**UPGRADE RPG HARDWARE FOR FUTURE DIGITAL
OR FRAME RELAY COMMUNICATIONS**

**DOPPLER METEOROLOGICAL RADAR
WSR-88D**

Upgrade Radar Product Generator (RPG) Hardware for Future Digital or Frame Relay Communications.

This routine modification provides hardware installation instructions to upgrade the RPG for future implementation of digital or frame relay communications. The authority for this modification is Radar Operations Center (ROC) Engineering Change Proposal (ECP) 0177, Upgrade RPG for Digital or Frame Relay Communications.

Figure 1. Router Location

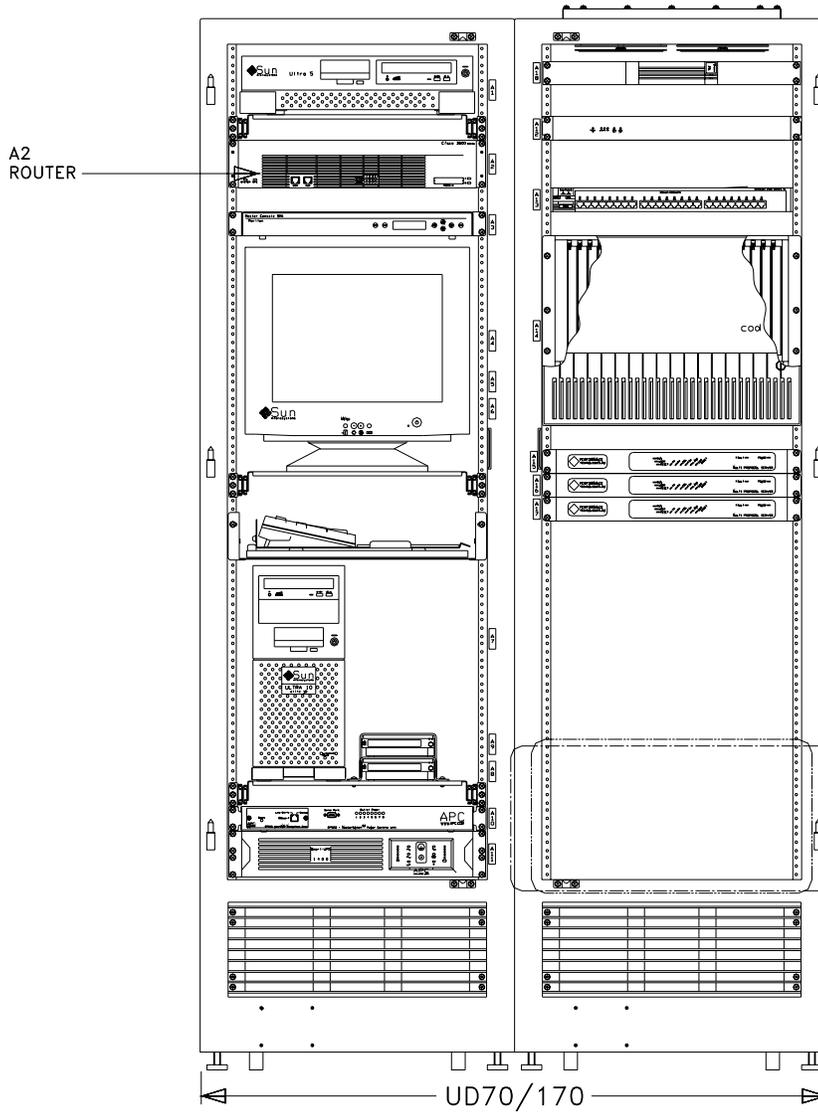
- e. Click on the **Close** button to close the *Console Messages* window.
2. Open the RPGPCA cabinet doors and locate the Router UD70A2. (Refer to [Figure 1](#) for router location.)

Figure 2. Router Module Location

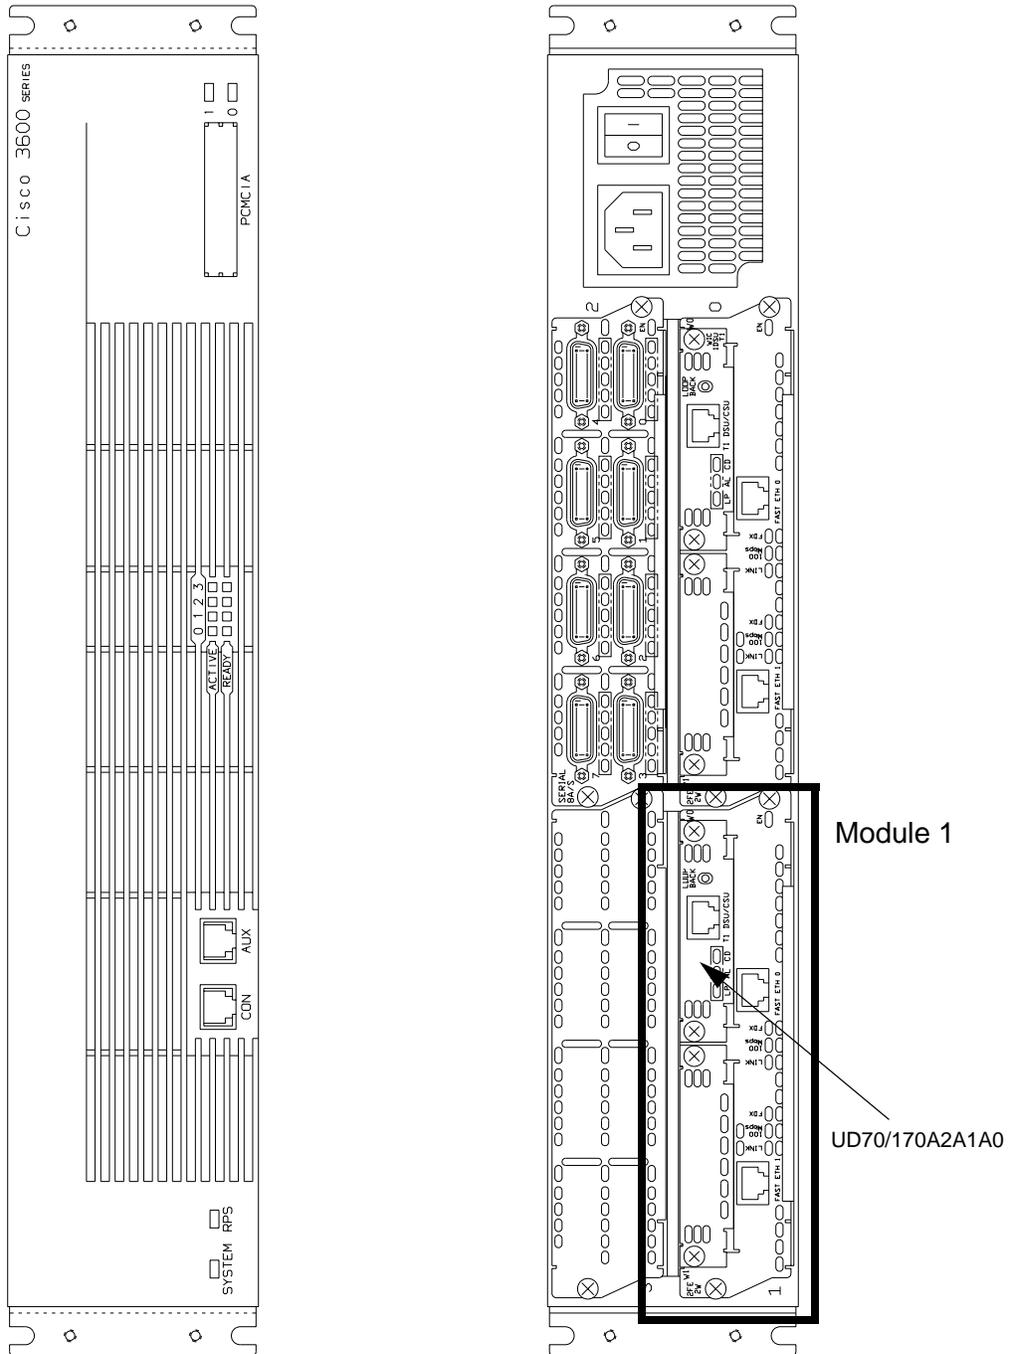
1. Put the ESD wrist strap on bare wrist and connect clip the lead to the chassis frame or proper ground.
2. Locate the modules installed in the back of the Router UD70A2. (Refer to [Figure 1](#) for the router location, and [Figure 2](#) for the router module locations.) Module 0 (UD70/170A2A1A0) is the bottom right module. Module 1 (UD70/170A2A1A1) is the bottom left module. The module number is engraved on the router case and may be difficult to see.

3. On Module 1 (UD70/170A2A1A0) on the back of the router:
 - a. Loosen the captive screws that hold the blank filler panel installed in Network Module Slot 1.

- b. Remove part number 2210022-204, the 2-Port 10/100 Ethernet Wan Card Slot Module from its conductive package.
 - c. Hold the Ethernet WAN Card by the edges and line the card up with the guides on either side of the network Module Slot 1.

- d. Insert the card in the slot and push it in until it is firmly seated in the connector and the card's front panel is flush with the router's rear panel and tighten the captive screws that are in the card.

- e. Remove the screws that hold the blank filler panel for WAN interface card slot W0 installed in Network Module Slot 1 of the two port Ethernet module and remove the metal covering plate.

- f. Remove part number 2210022-202, the 1-Port T1/Fractional T1 DSU/CSU Wan Interface Card from its conductive package.
 - g. Hold the WAN Interface Card by the edges and line the card up with the guides on either side of the WAN interface card slot W0.

- h. Insert the card in the slot and push it in until it is firmly seated in the connector and the card's front panel is flush with the router's rear panel and tighten the captive screws that are in the card.
